# SERVICE BULLETIN

M-856

## SERVICE INFORMATION — 1983 XL MODELS

Figure 1. Piston with Rings — 1983

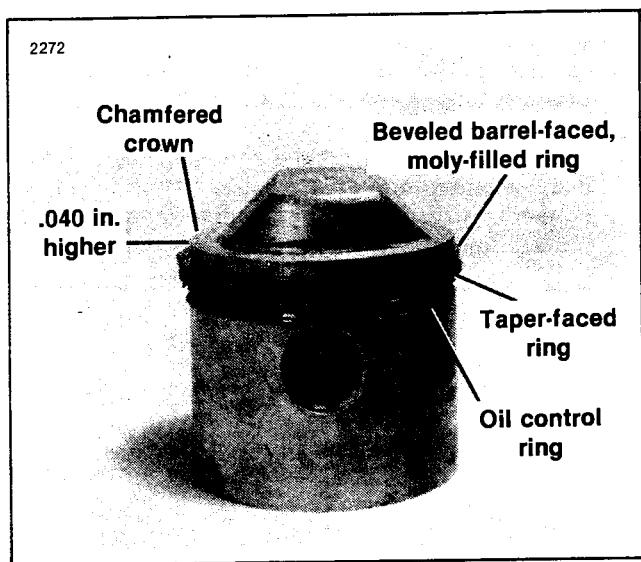
See Figure 1. The new piston crown surface is .040 in. higher. This higher compression piston can be identified by the chamfered edge on the piston crown. Piston rings include a beveled barrel-faced, moly-filled top ring, a taper-faced second ring and a three-piece oil control ring with two chrome plated rails and a corrugated expander.

Figure 2. Vacuum Operated Electric Switch (V.O.E.S.)

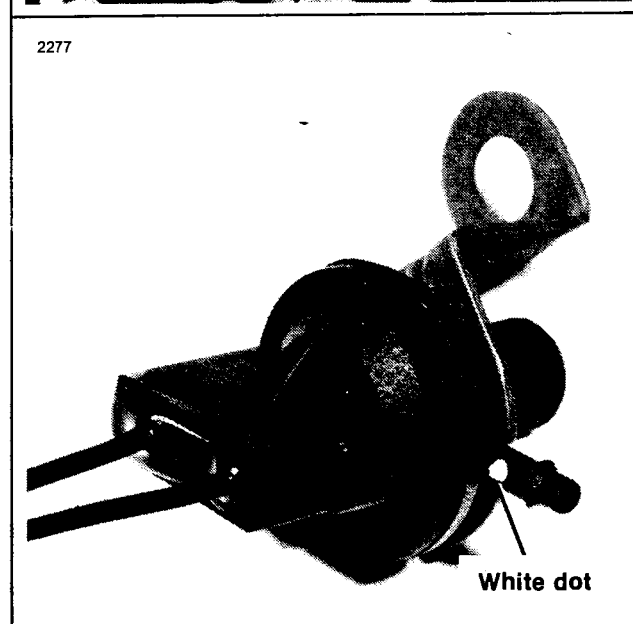
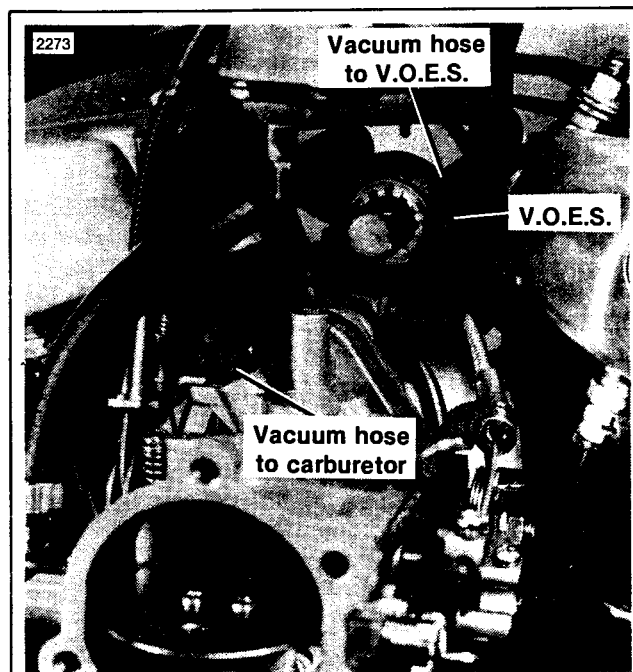
*Early build XLX models may have a V.O.E.S. with a vacuum operating requirement of 7 in-Hg resulting in a longer than necessary retarded ignition curve. This V.O.E.S. should be replaced with a new V.O.E.S. requiring only a 4 in-Hg vacuum for operation. The new V.O.E.S. is identified by a white dot at the vacuum hose connection as shown in Figure 2.*

Affected dealers should order the proper quantity of correct vacuum operated electric switches for XLX motorcycles shipped to their dealership having a V.O.E.S. **without** a white dot under Part No. 26557-83.

When the vacuum operated electric switches are received, they should be installed immediately in all affected motorcycles.
